Lake City Community Center

Design Commission #2 February 19, 2026

Responses to Design Commission Meeting #1 Recommendations

RESPONSES TO RECOMMENDATIONS #5 & 9

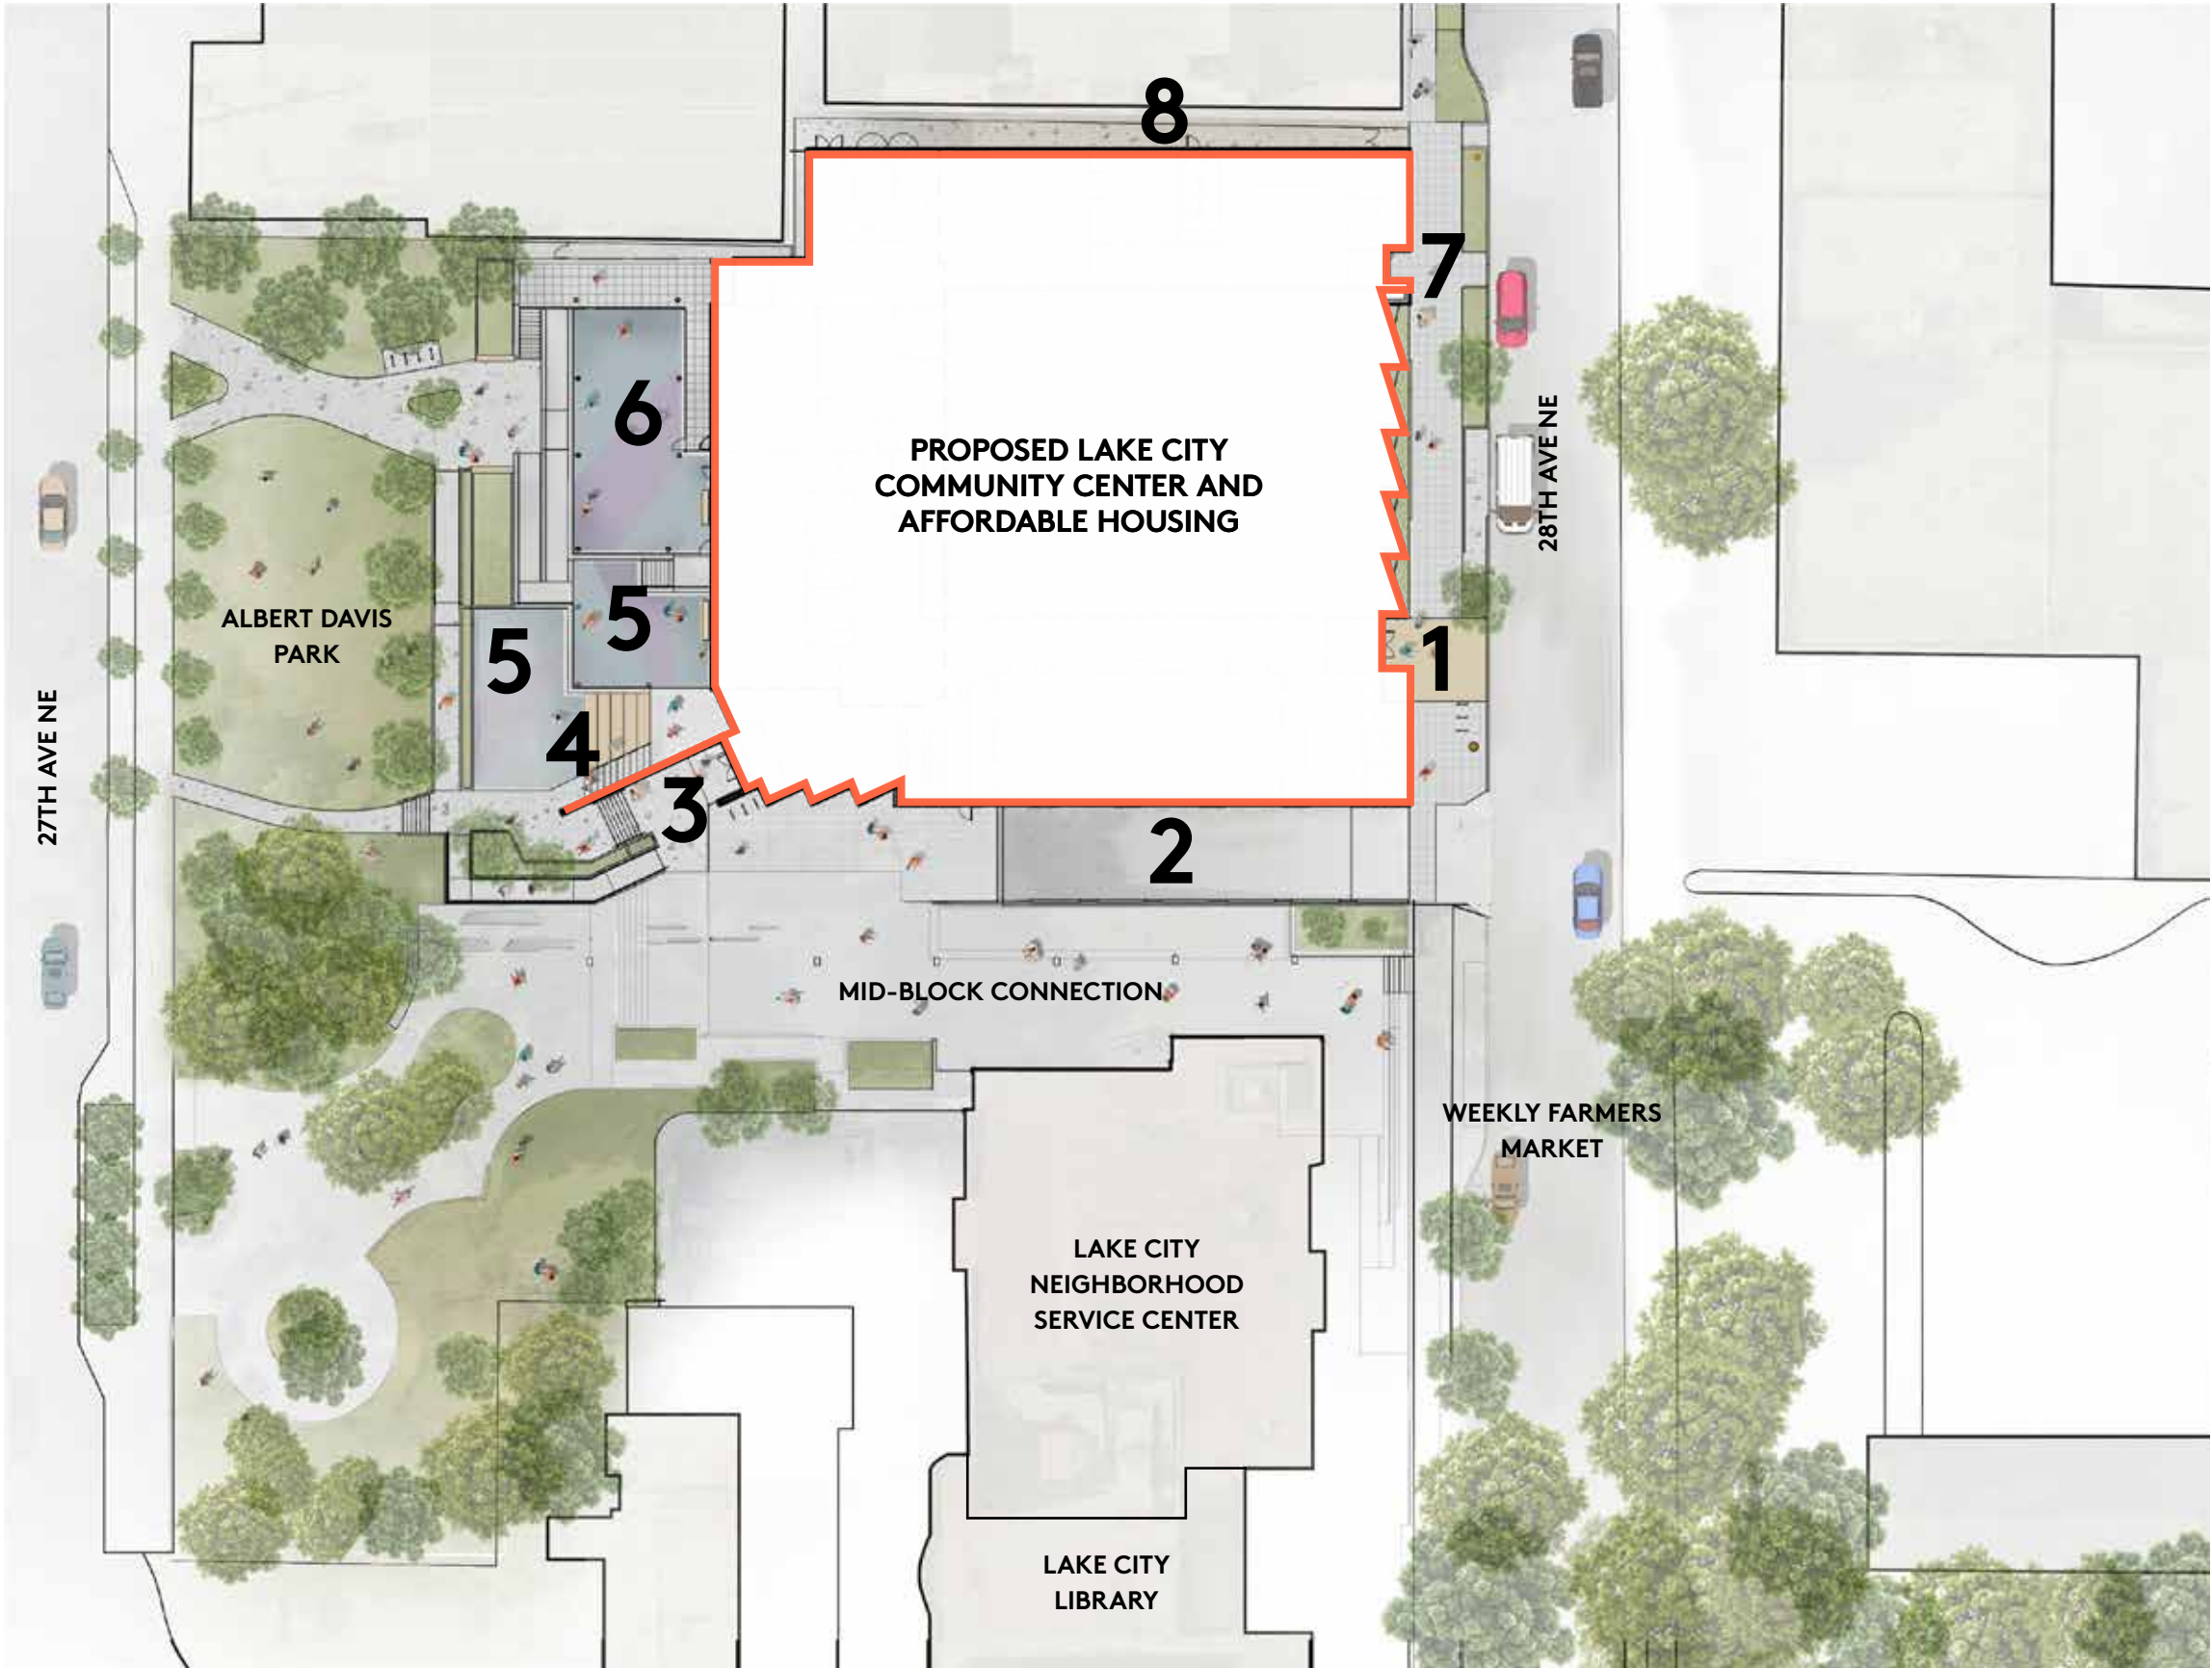
#5 Coordinate with adjacent uses

Better integrate exterior programming areas with library, service center, and mid-block connection

#9 Consider microgrid opportunities

Study partnership with Seattle City Light
